Subject: FW: FW: Sabina Chowdhury Rezoning 8/5/2024

Please see the email below and attachments referenced regarding the Gillsville Highway rezoning request that comes before you this Thursday 10/24.

In summary, Steve Gilliam has provided comments addressing the passing lane, deceleration lane, and site distance issues that were raised in the Planning Commission meeting, as well as the size of the lots in relation to the septic regulations. There are no changes to the site plan or the narrative at this time.

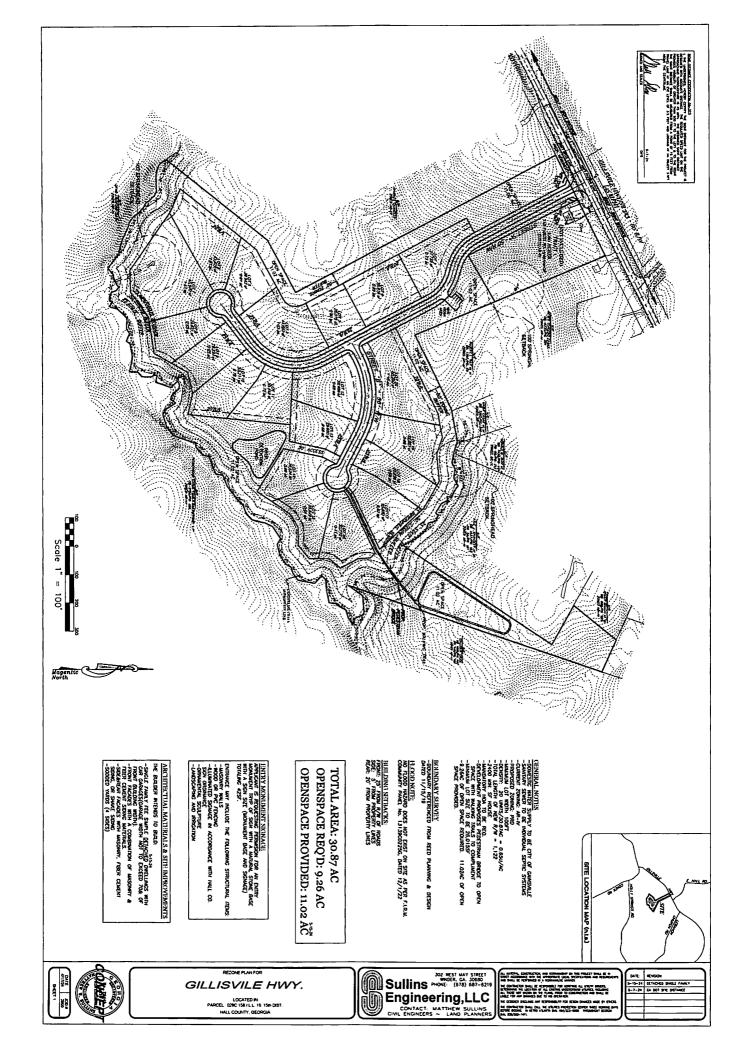
The only per GA DOT standards to remove the 100ft Right Hand Passing Lane would be to reduce the number of lots in the subdivision.

The threshold for requiring the 100ft Right Hand Passing Lane is 75 Left Turns per day and currently as designed we are yielding 80 Left Hand Turns per day.

Each lot is responsible for 4-5 Left Hand Trips per day so the lot yield would have to be reduced by two if we wanted to have an argument with the DOT to not have to provide any kind of left turn lane.

FYI. Even if we reduced the lot count by two there is still a possibility they could still require a passing lane BUT we would have a real good argument.
